ADDENDUM NO. 2
March 17, 2023
225107

RE: ALBURGH VILLAGE WATER TANK REPLACEMENT

FROM: DuBOIS & KING, INC.
P.O. Box 339
Randolph, Vermont 05060
(802) 728-3376

TO: Prospective Bidders

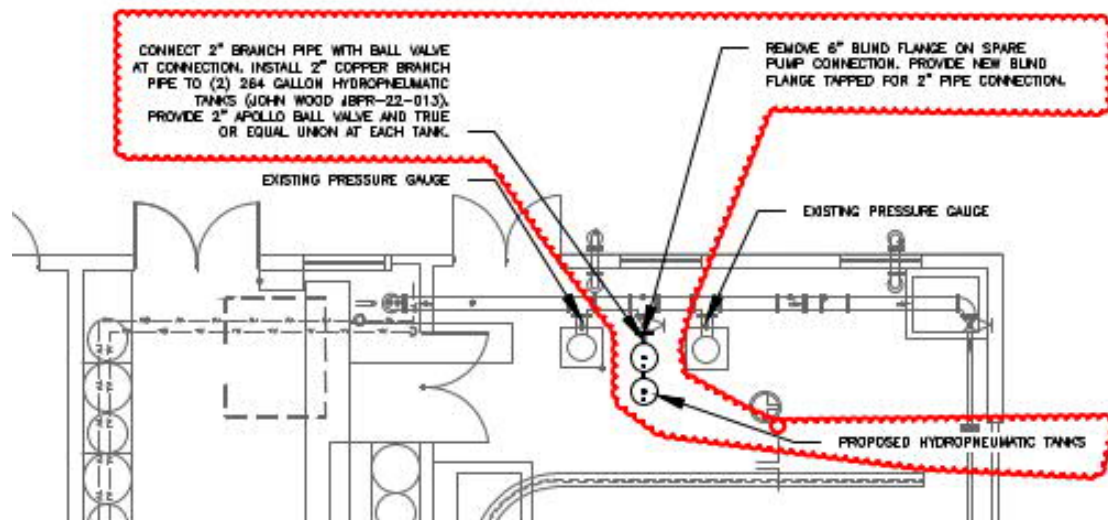
Question 12: What work on Drawing C11 is included in the contractor's scope and to be included in the bid?

Answer 12: The work in the Contractor's scope is described in Specification 01150 3.02.A.13 and marked in revision cloud on the drawing excerpt below as well as the controls system as described in Answer 36.
